IFB 19-002 LIFT STATION C FORCE MAIN REPLACEMENT

ADDENDUM #5

Subject: Questions & Answers

GULF OF MEXICO DRIVE PAVEMENT RESTORATION

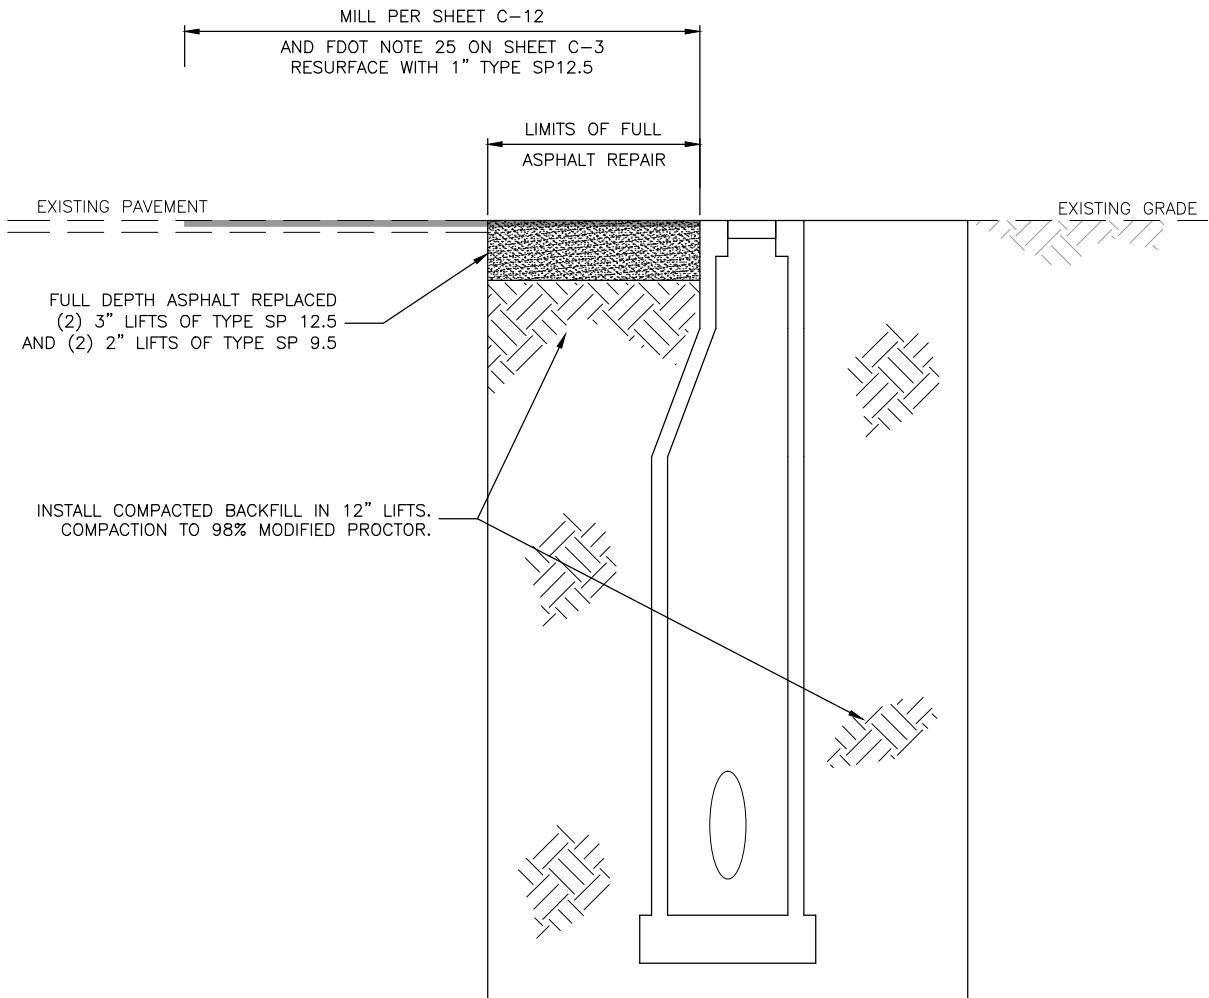
Question 1: We are in receipt of Addendum Four and take issue with the flowable fill as base material and ask that a detail as required by Note 25, second sentence, on plan sheet C-3, be provided that specifically addresses surface restoration work in the Florida Department of Transportation’s right-of-way. Currently, there is no detail addressing this scope of work. Please provide.

Answer: Please see attached Figure 1 including a detail for FDOT Right-of-Way pavement restoration on Gulf of Mexico Drive.
